City of White Salmon
 Recommendation to Planning
 Commission

Cherry Hill Estates Preliminary
 Plat

WS-SUB-2024.001 and WS-SEPA-2024.001
 Applicants: Alex Pedroza of HRK Engineering &
 Field Services, representing Cherry Hill NW, LLC
 and Cameron Curtis of Legacy Development
 Group

STAFF RECOMMENDATION
 Amended December 5, 2024

EXISTING CONDITIONS

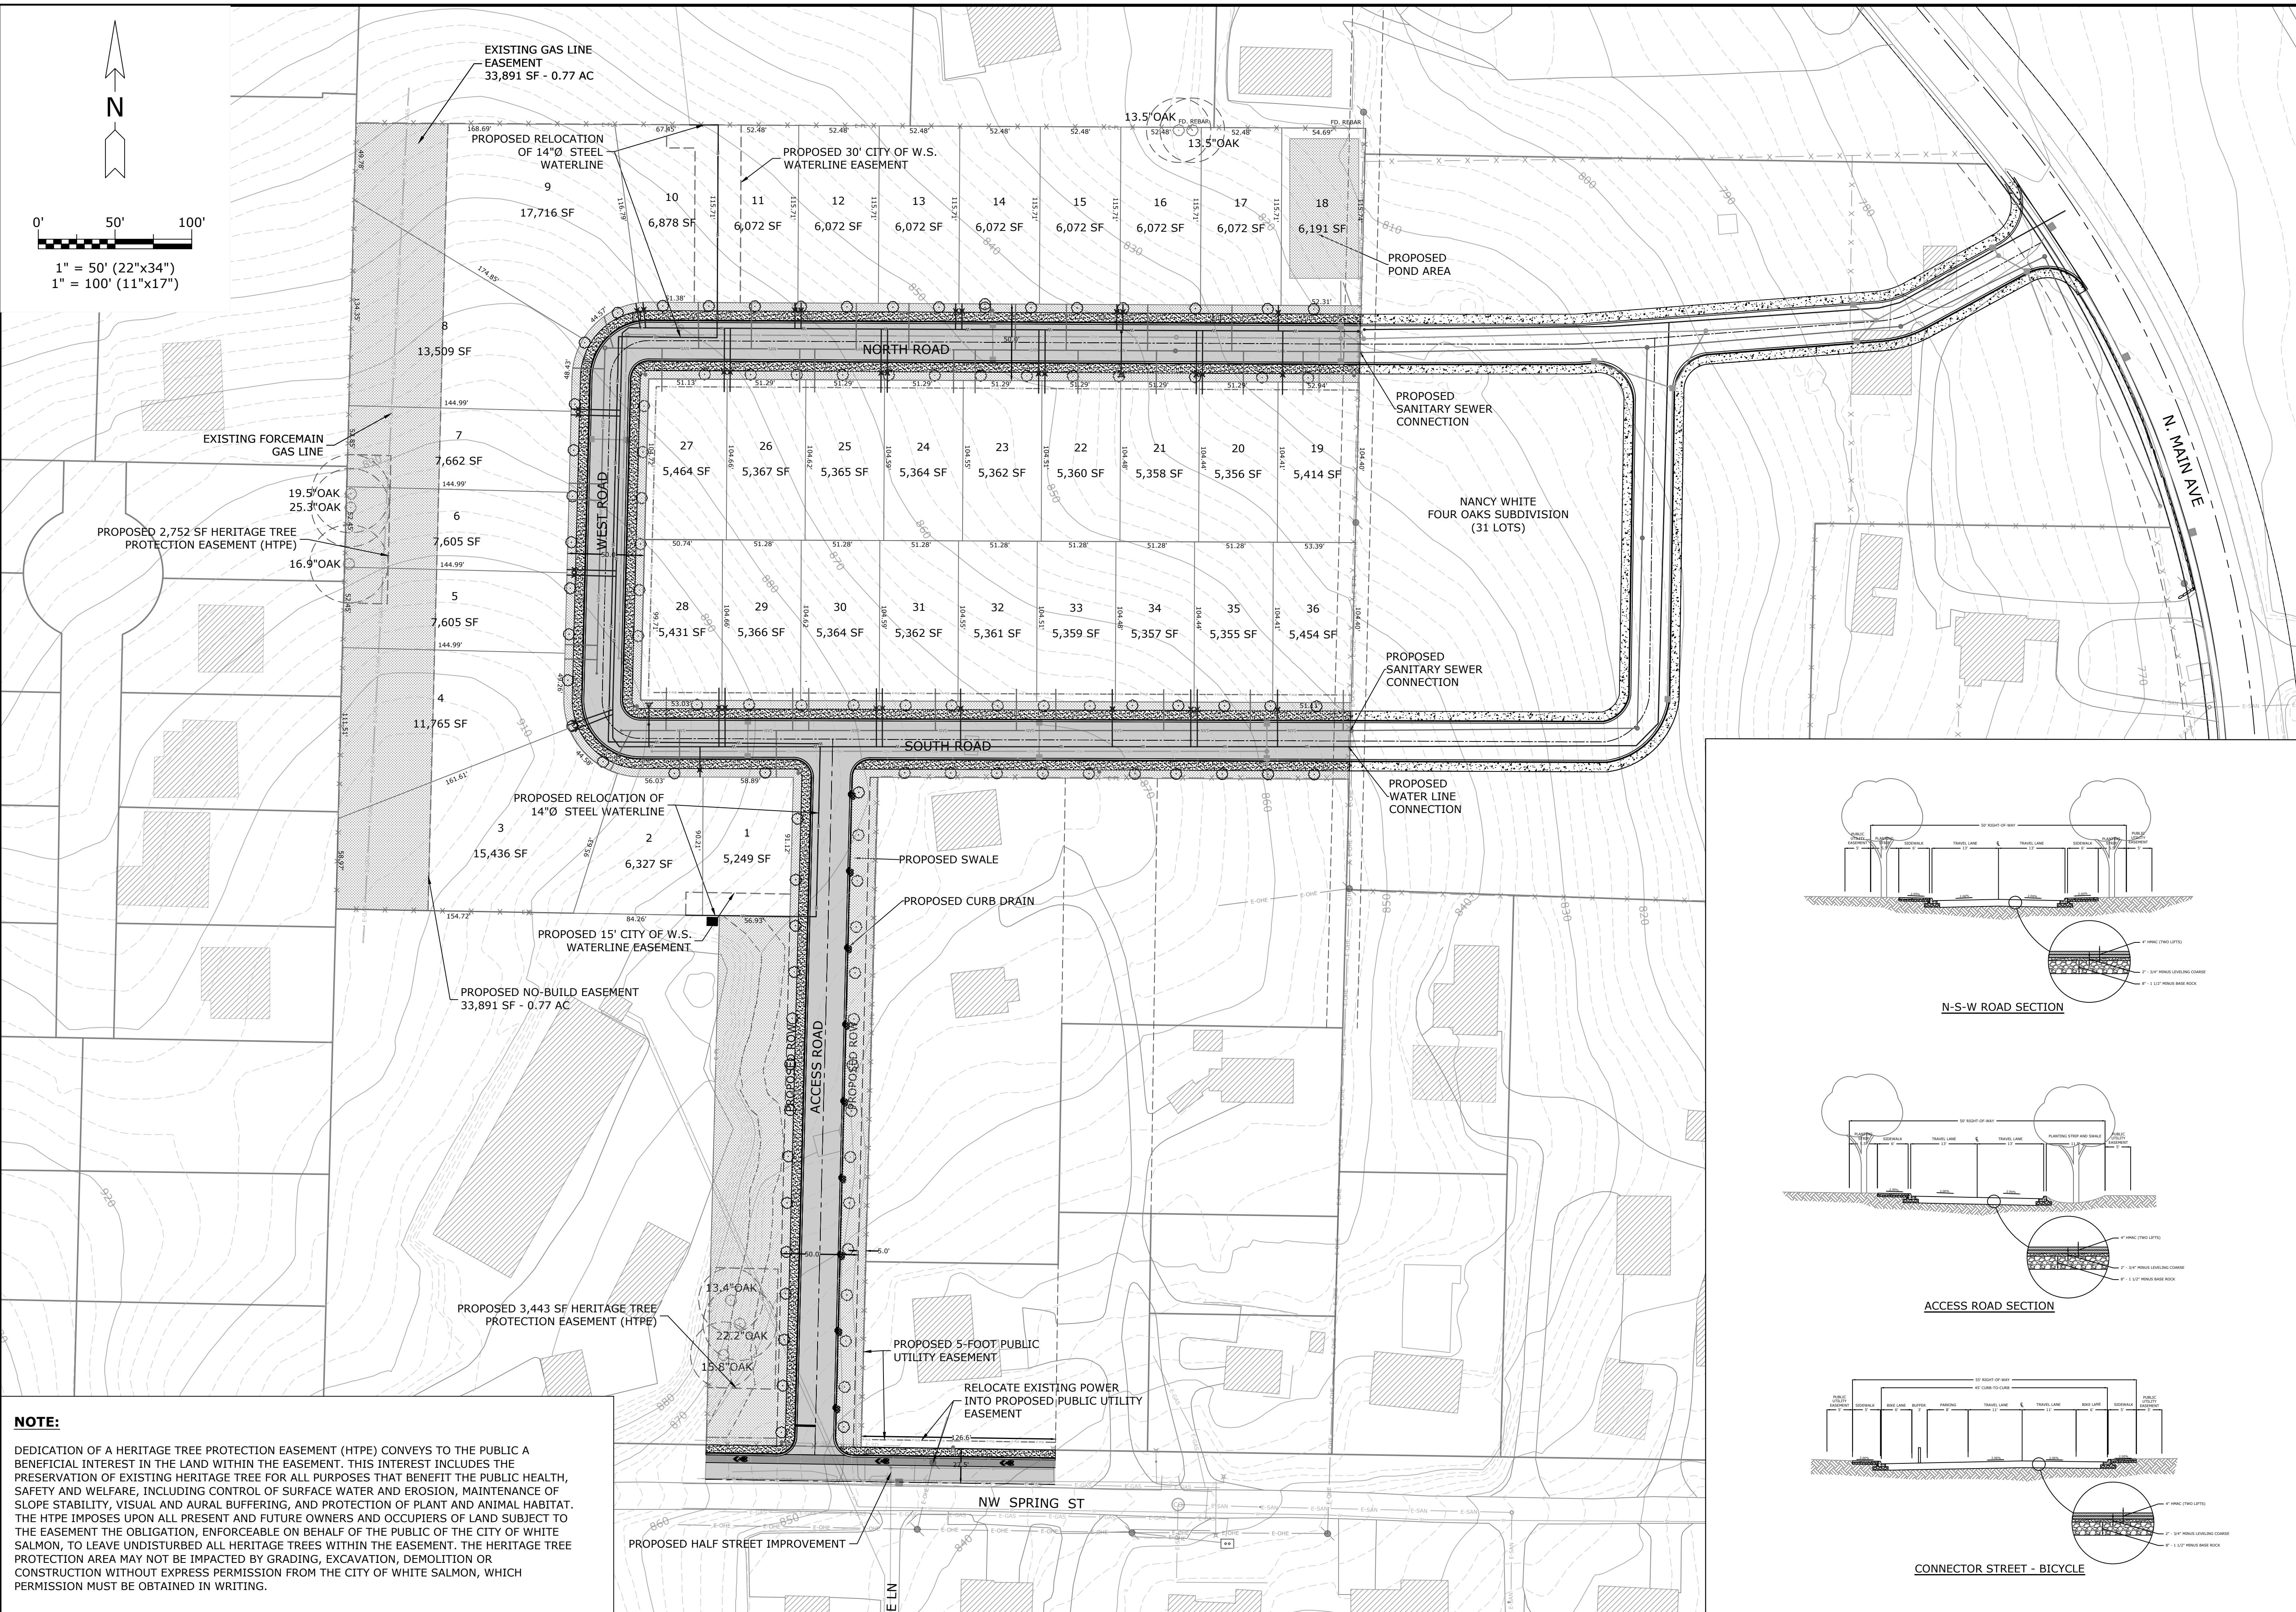
FINDING – Upon further review of site critical area constraints, a regulated steep slope exists along the southwestern boundary of the site, as mapped on sheet 2 of Exhibit 3. Per review of the project geotechnical report (Exhibit 9), the access easement does not impact this critical area or its proposed buffer.

SHEET NAME
 SITE PLAN
 SHEET NO.
 3 OF 4

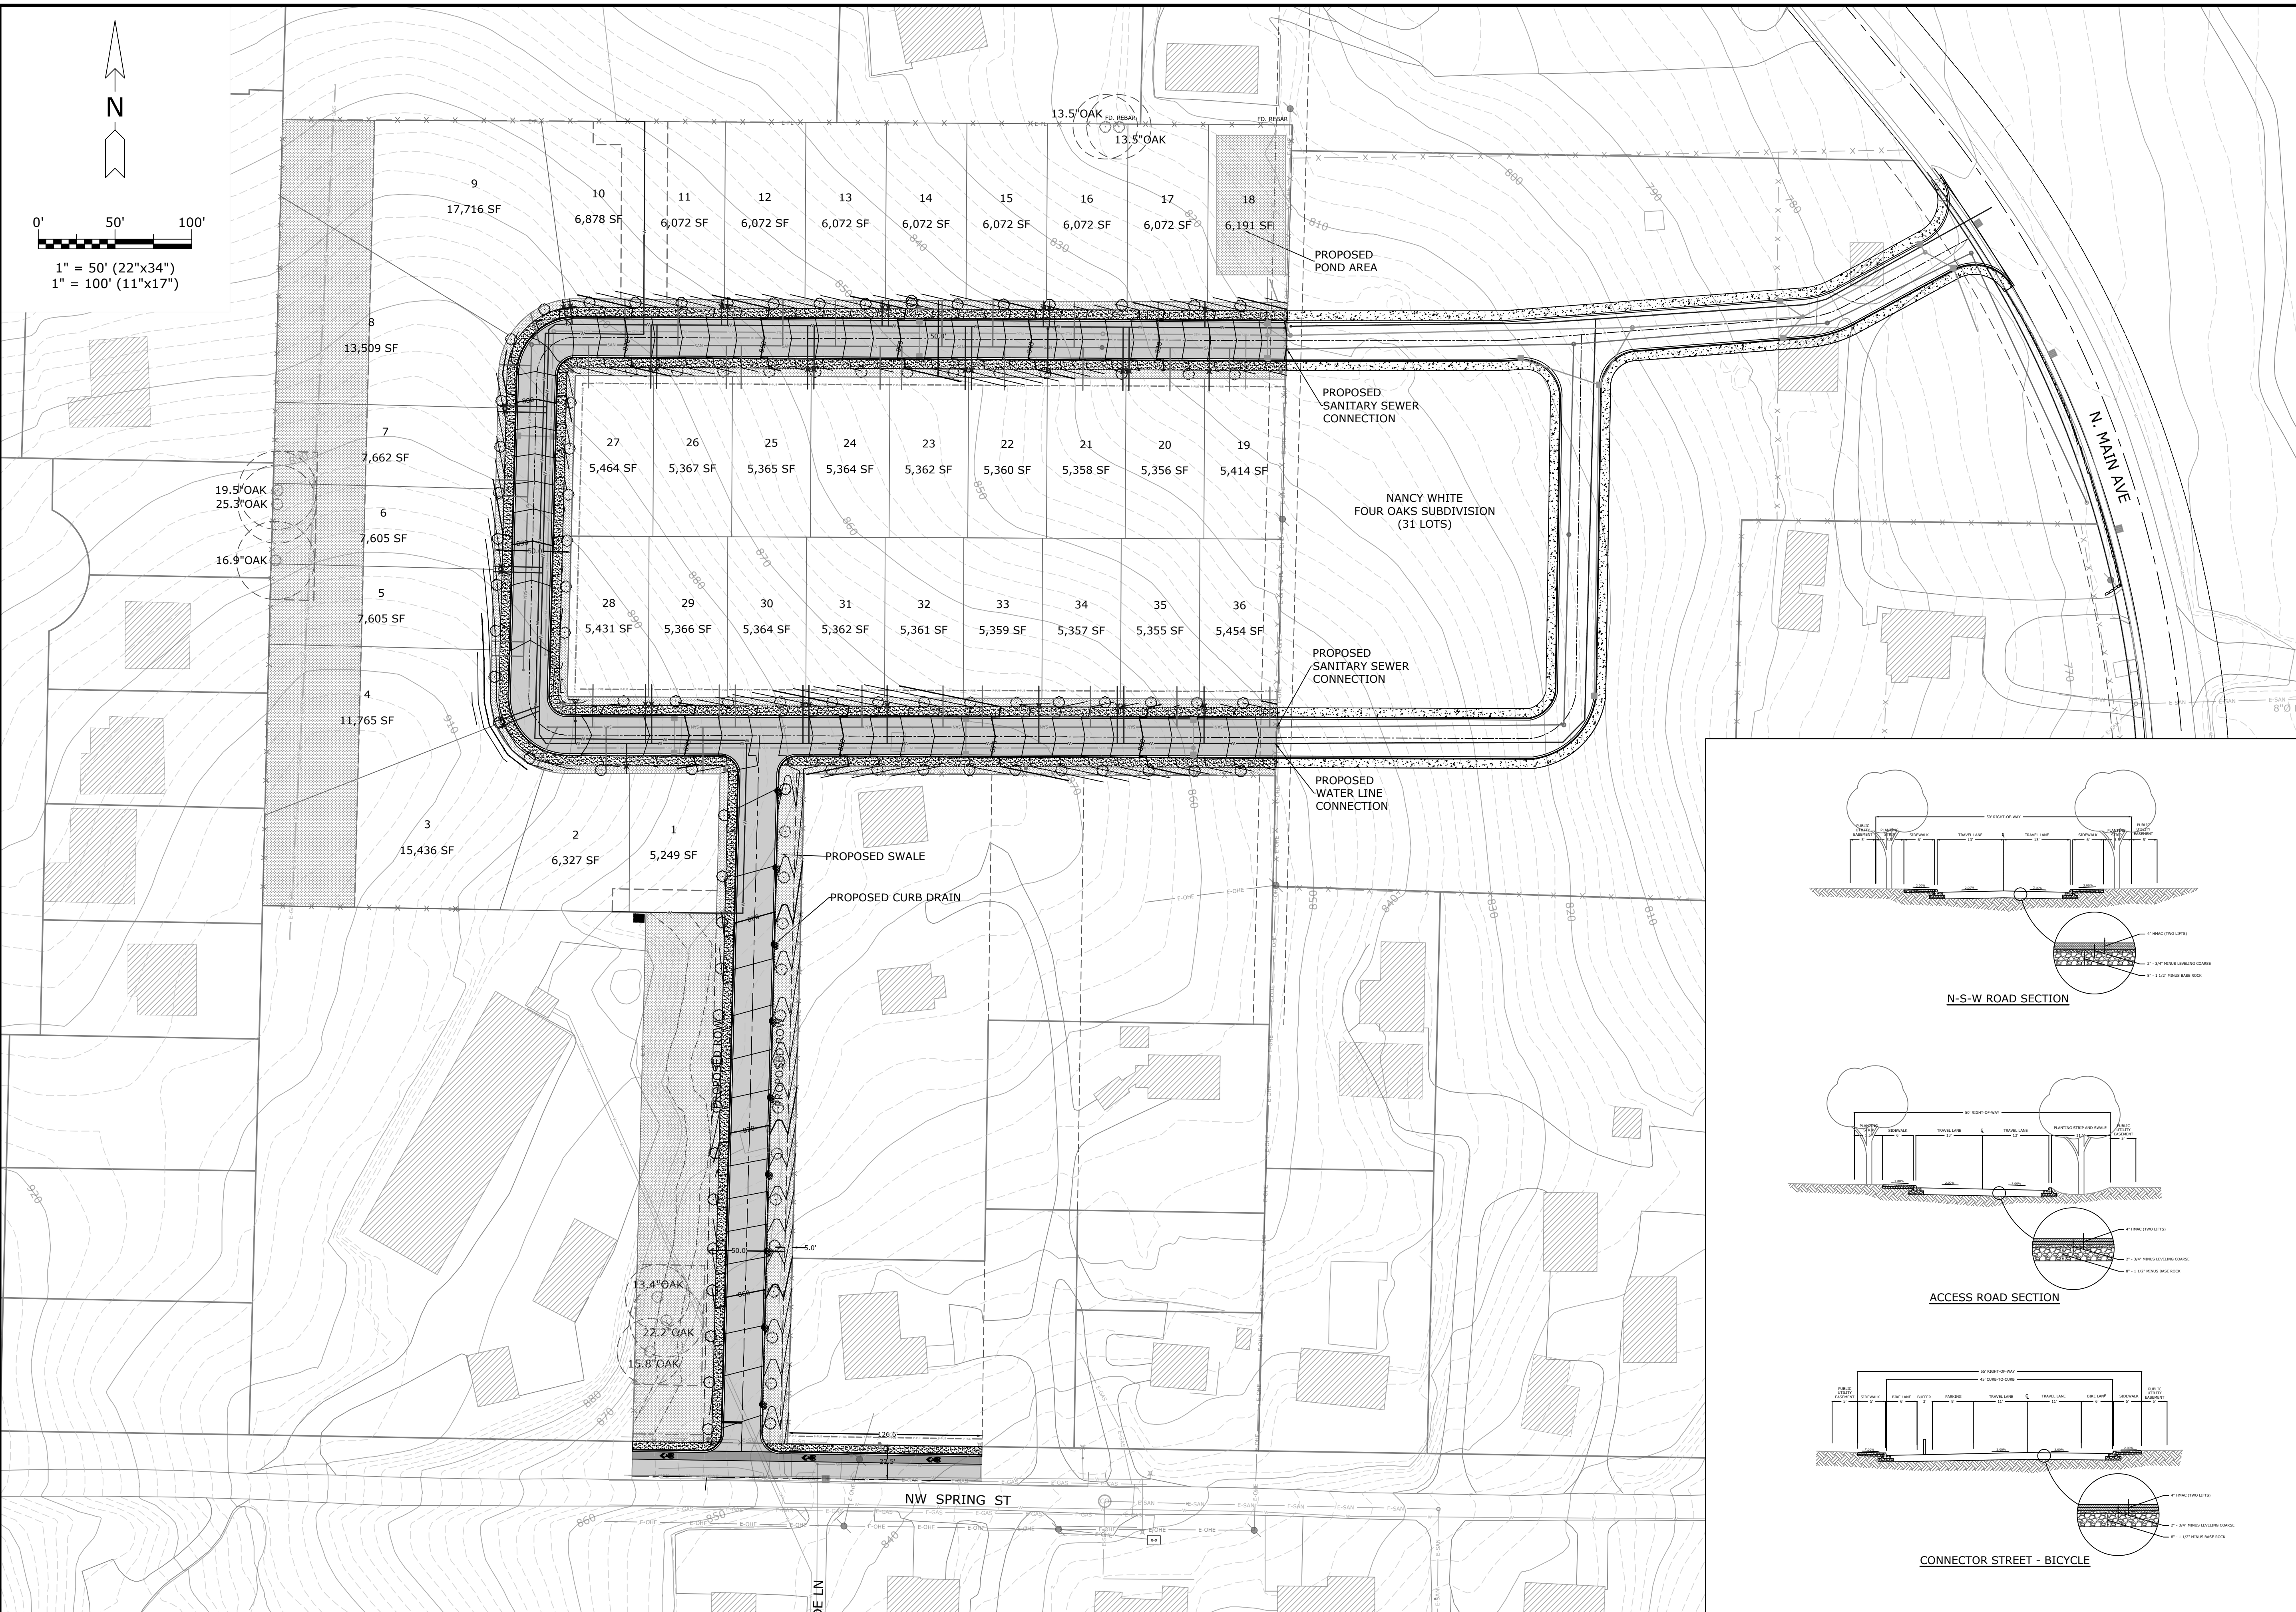
2. Please show the proposed water line easement benefitting the City, bordering proposed lots 8, 9 and 18, as shown on sheet 3 of the site plan.
3. *Please provide an arborist report to evaluate the presence or absence of heritage trees, as defined and regulated under WSMC 18.10.317. If found, please provide an assessment of protection needs on-site.*

FIGURE 3: TRIP DISTRIBUTION AND PROJECT TRIPS

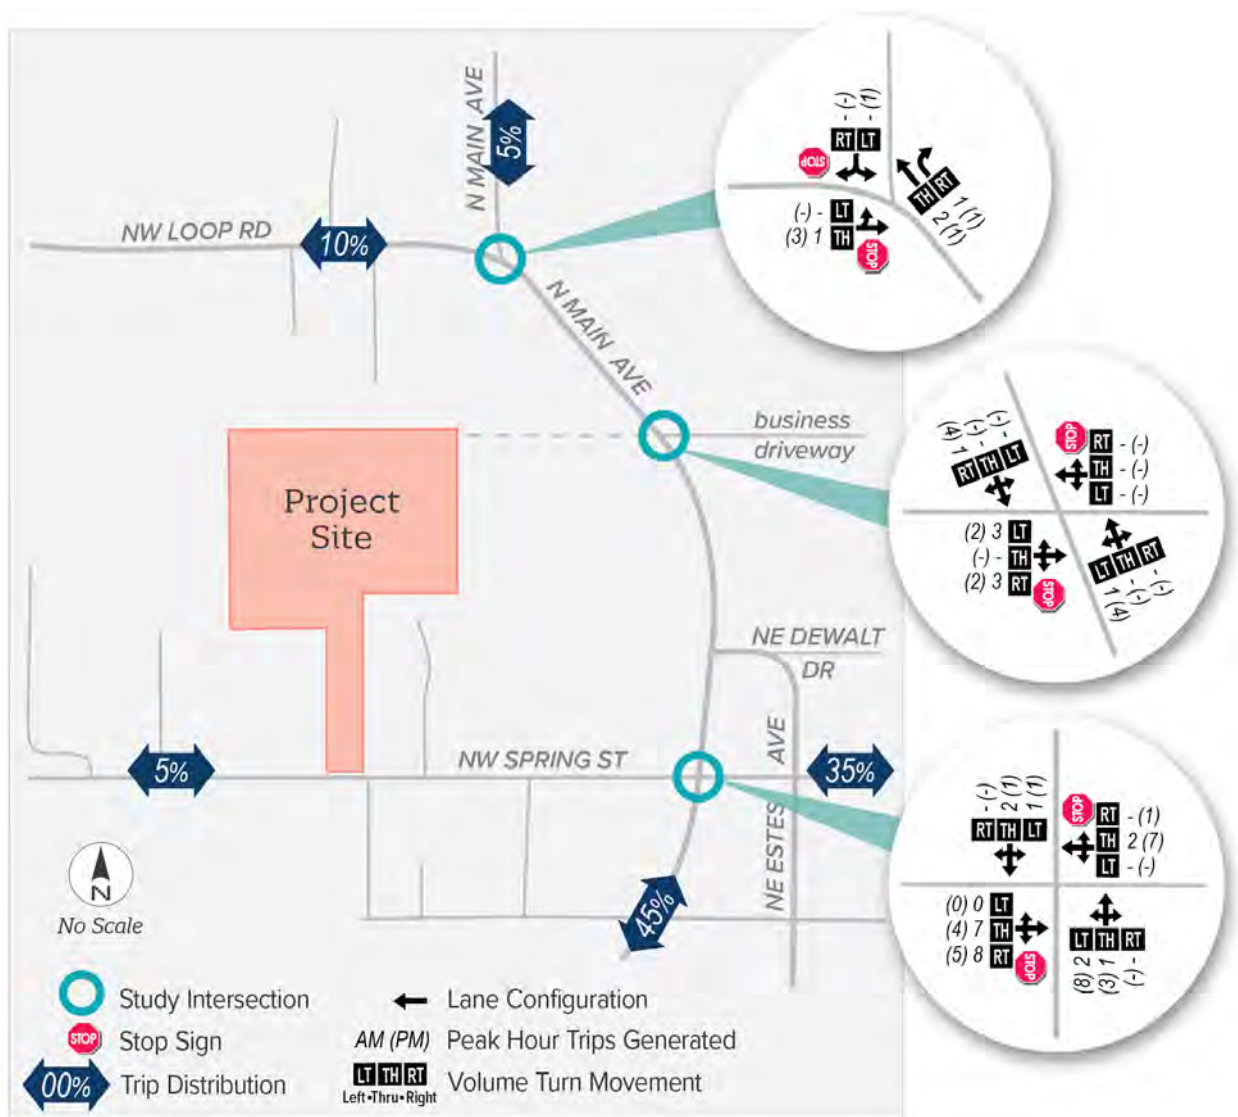
DKS Response: Should access onto Main Street not be permitted, all traffic generated by the development would enter/exit the site via the access on NW Spring Street. Per Figure 3 in the TIS, this would result in most (95%) of trips traveling through the intersection of NW Spring Street/N Main Avenue. As shown in Table 5 of the TIS under the Future 2027 Build condition (which assumes roughly 80% of the project trips travel through the intersection at NW Spring Street/N Maine Avenue), drivers on Spring Street will experience an average of 11 seconds of delay when turning onto Main Avenue, which is an increase of less than half a second over the No-Build condition. Additionally, the volume-to-capacity ratio (v/c) shows that roughly 12% of the capacity of the intersection will be utilized. Based on this, it can be assumed that the average driver delay at the intersection would increase by a very minimal amount (one or two seconds) and that there would be plenty of capacity remaining at the intersection should the proposed subdivision only have access to NW Spring Street.
